Owner Change Order

Canon City Middle School 1215 Main St. Canon City, CO 81212	Project # 1902 Tel: 719.473.5321 Fax:	G. E. Johnson Construction Company, Inc.
--	---	---

ARCHITECT'S SUPPLEMENTAL INSTRUCTIONS

PROJECT:	Canon City Middle School Renovation and Addition	SUPPLEMENTAL INSTRUCTION NO.:	34-CCMS
OWNER:	RLH Engineering c/o Chuck Jordan 601 Gyrfalcon Court, Unit A Windsor, Colorado 80550	DATE OF ISSUANCE:	12/19/2019
CONTRACTOR:	GE Johnson 25 North Cascade, Suite 400 Colorado Springs, CO 80903	ARCHITECT PROJECT NO.:	18012.01
		ARCHITECT:	R.T.A., Inc. 19 South Tejon Street, Suite 300 Colorado Springs, Co 80903

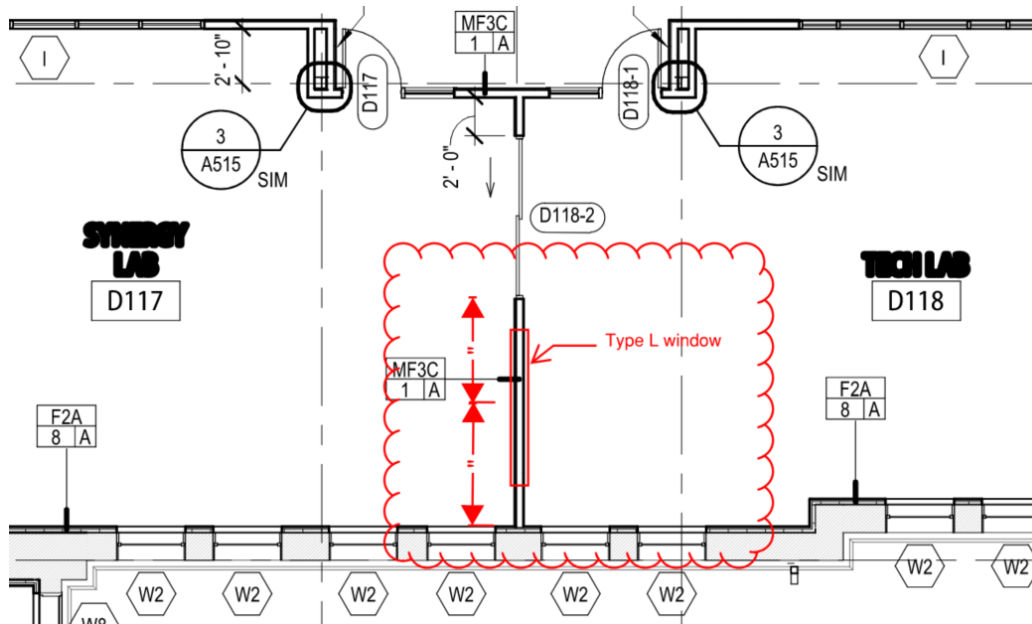
*Door to be locked from Room C312 side of opening.
